Anglia Square, Norwich  
Proposed Surface Water  
Drainage Strategy  
Rev C

**JOB NUMBER:** 3831/2022  
**DOCUMENT REF:** SUDS/3831/2022  
**REVISIONS:** F – REV C SUBMISSION

### SuDS Strategy Anglia Square Regeneration

## Appendix: G – Existing Impermeable Areas and Drainage Catchments

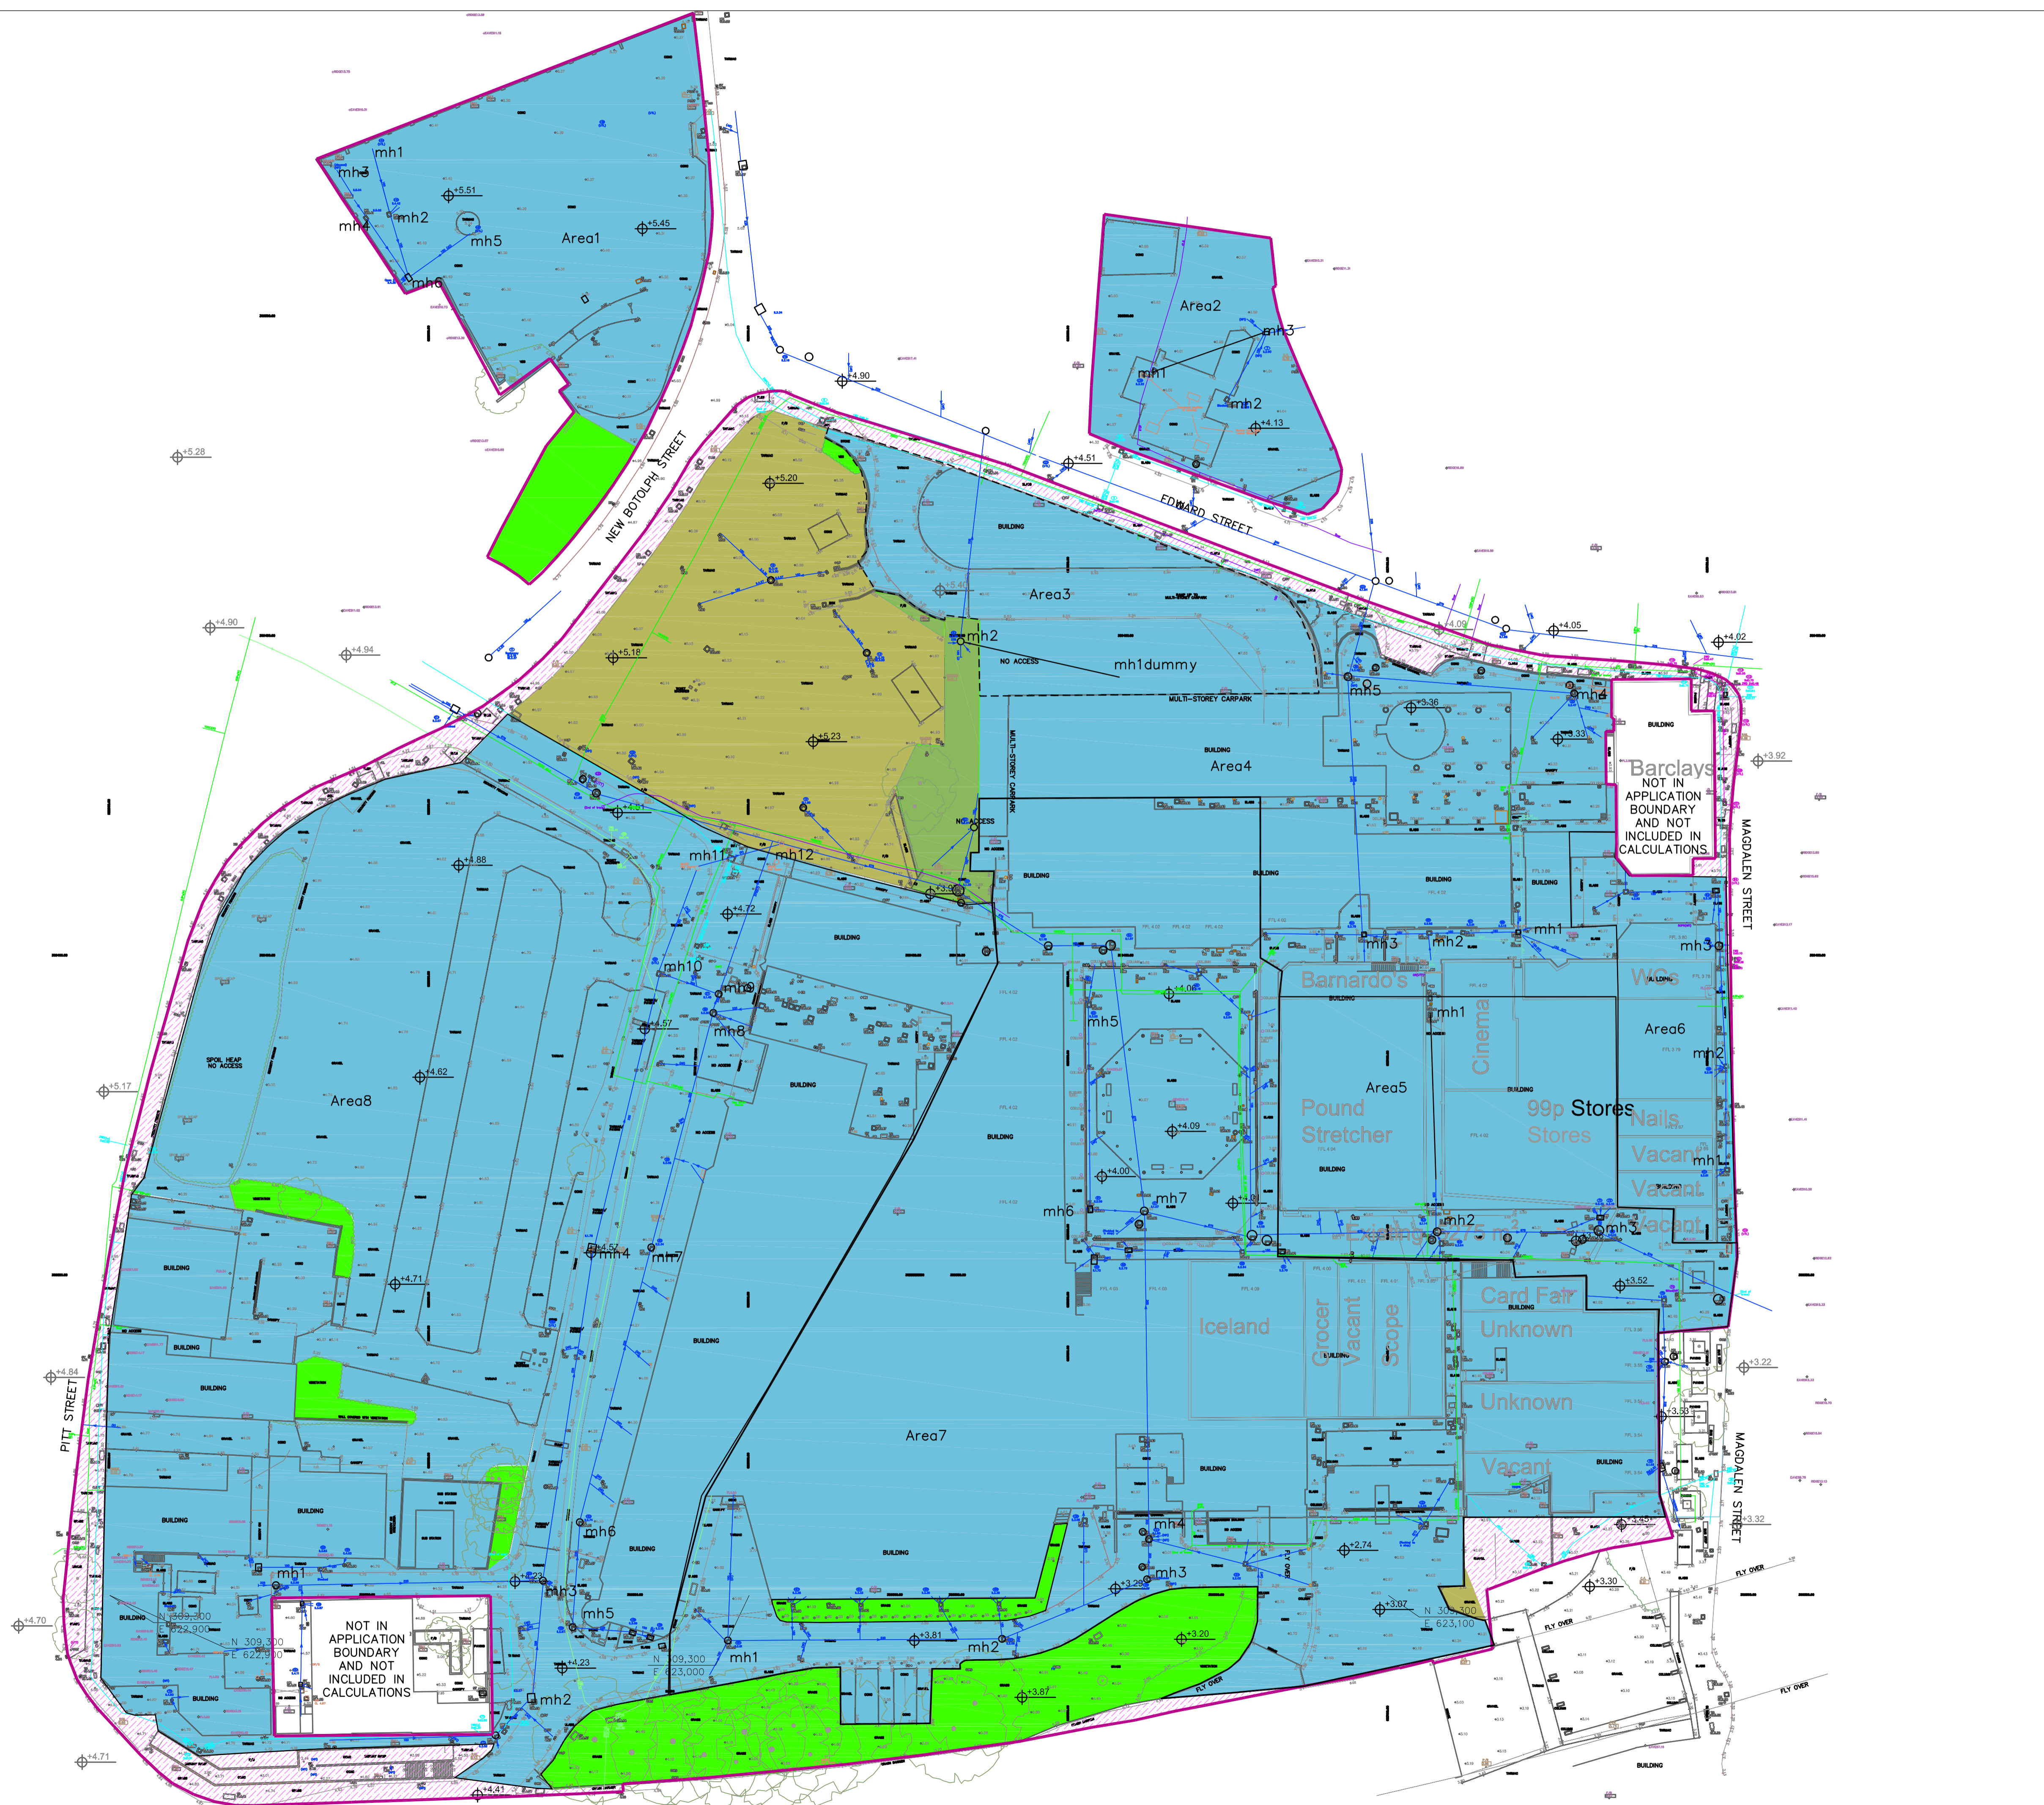
- 3.17 SK01-D in Appendix G shows the existing impermeable and permeable areas as well as the existing drainage systems serving the site and their catchment areas. The site is split into 8no. catchments areas. In their consultation comments (ref FW2022\_0703) the LLFA requested that a section of landscaped area to the west of Area 4 (395m<sup>2</sup>) should be included in the brownfield runoff rates, as such, the greenfield runoff rate for this area shall be added to the calculations.

- 3.18 Greenfield Run-off Rates are discussed below. In order to avoid overestimation of brownfield runoff rates and provide a robust calculation, a brown-coloured car park area to the west of Area 3 (2814m<sup>2</sup>) is not included in the impermeable area as the drainage survey is incomplete and does not confirm where this area drains to. It would therefore be inappropriate to include this within the following calculations. The total contributing area for brownfield runoff is therefore 3.9577ha (including 395m<sup>2</sup> of landscaped area).

- 3.19 The CCTV Drainage survey and topographical drainage survey show that surface water runoff from the existing site (with the exception of the brown-coloured car park area of 2814m<sup>2</sup> and landscaped areas of 1845m<sup>2</sup>) is directed adopted surface water sewers in Edward Street, the 675dia sewer crossing Anglia Square and the 36" sewer in Magdalen Street. Looking at SK01-D in Appendix G it can be determined:
